CITY OF ALBUQUERQUE

RE: **Behavioral Health Hospital**
1525 Renaissance Blvd NE
Grading Plan Stamp Date: 10/1/18
Drainage Report Stamp Date: 10/1/18
Hydrology File: F16D051A

Based on the submittal received on 10/2/18, the grading plan and drainage report cannot be approved until the following are corrected and a complete resubmittal is made:

BEHAVIORAL HEALTH HOSPITAL RENAISSANCE CENTER	DRAWN BY DY
	GRADING AND DRAINAGE PLAN	DATE 9/26/18
	TIERRA WEST, LLC 5571 MIDWAY PARK PLACE NE ALBUQUERQUE, NM 87109 (505) 858-3100 www.tierrawestllc.com	2017054-GR
		SHEET # C3
RONALD R. BOHANNAN P.E. #7868		JOB # 2017054

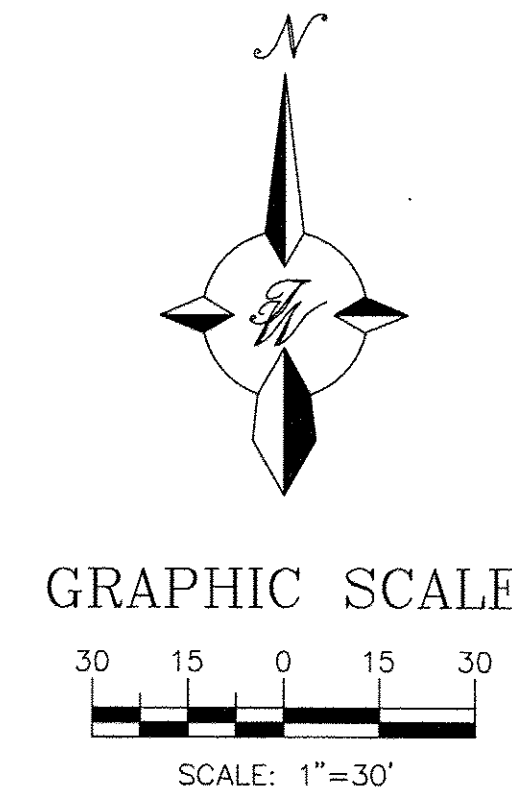
1. Provide written permission from the owner of Tr 9A-1A (FritoLay) for the regrading of the pond on their property.
2. On the grading plan, add existing contour labels; increase the density of the proposed contour labels, especially around the ponds and when tying in at the property/ROW lines.

3. Land treatments need to be revisited. Many of the sloped areas are assumed as land treatment B. Per the DPM Ch22.1.A, table A-4, *...soil uncompacted by human activity with slopes at 20 percent or greater* should be land treatment C and *...irrigated lawns and parks with slopes greater than 10 percent* should be land treatment C.

4. If these sloped areas are to be landscaped (w/ gravel mulch) please state on plans; otherwise annotate that disturbed areas are to be reseeded per Std Specification Section 1012.

5. Call-out Std Dwg 2426 and 2420 for the drive entrance.
6. Include project benchmark and datum.
7. Provide sections through the ponds and across the property line onto FedEx. Show 100-yr water surface elevations, tops and bottoms of berms. What design considerations were made to ensure FedEx is protected by the proposed berms? Hydrology recommends following levee and berm criteria per DPM Ch22.3.F.

8. Provide emergency spillways for the ponds, sized for the 100-yr storm inflow, or provide 2x capacity in the discharge pipes. Show the 100-yr and first flush water surface elevations for the ponds.
